CO Approved 7-29-08

PAVING & UTILITY PLAN
ROCKWALL OFFICE PARK - PHASE 3
CITY OF ROCKWALL

LANDSCAPE PLAN

HORIZON RIDGE OFFICE PARK
 BUILDING 3 and 4
 ROCKWALL, TEXAS

sheet
L-1

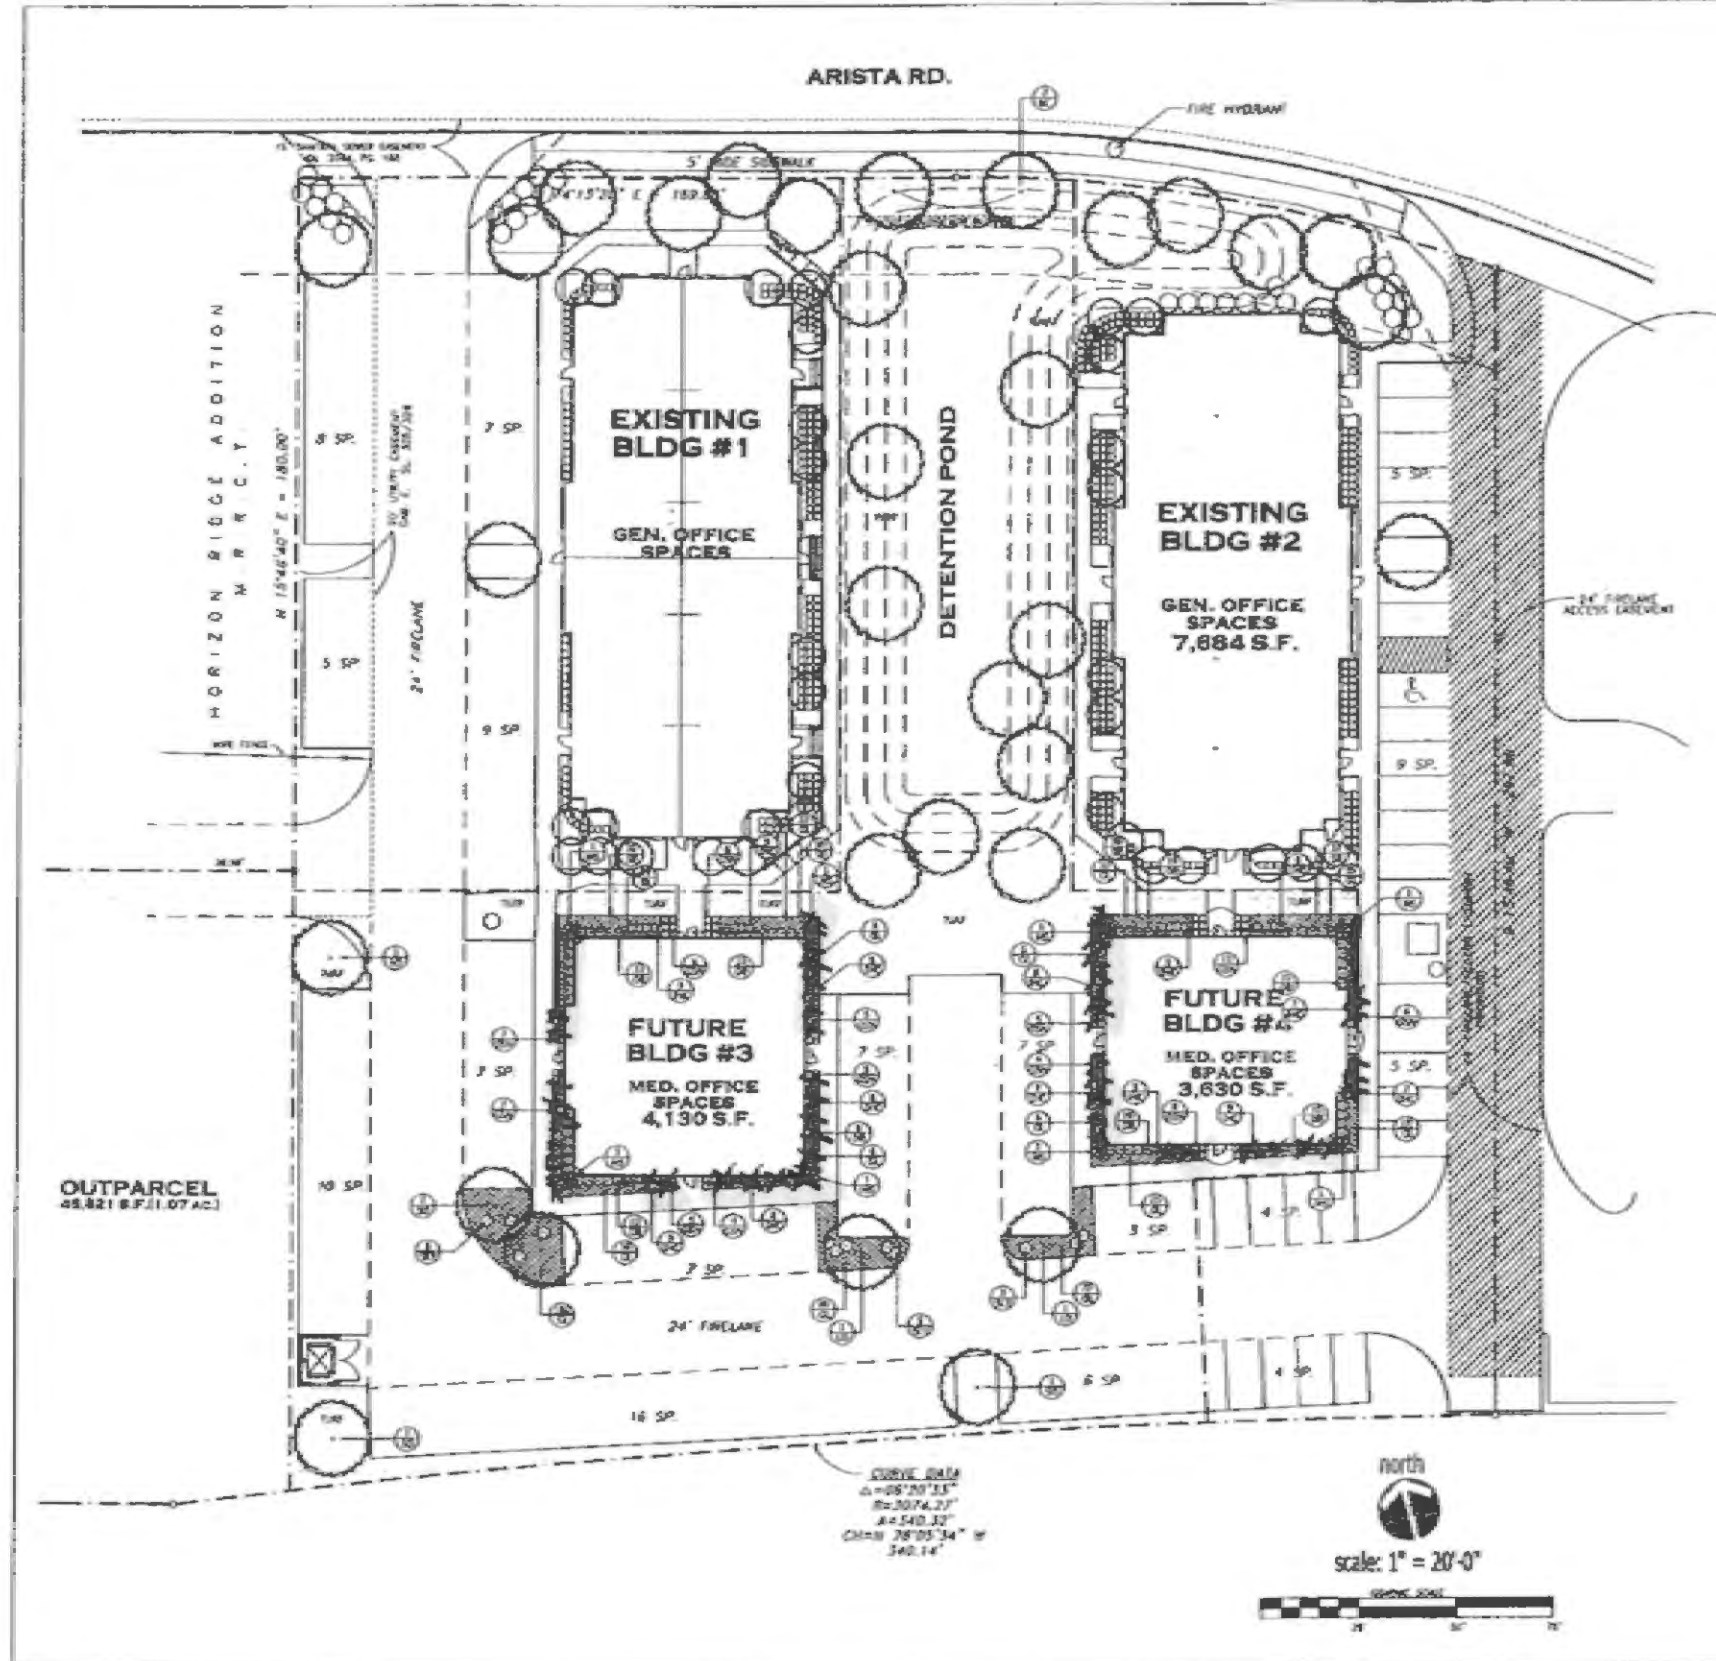
Disturbance caused from utility (Dry) extension

XX - new proposed landscape beds.

MH 8-20-08
 Approved relocation shrubs/grandover to areas shown attached Grad
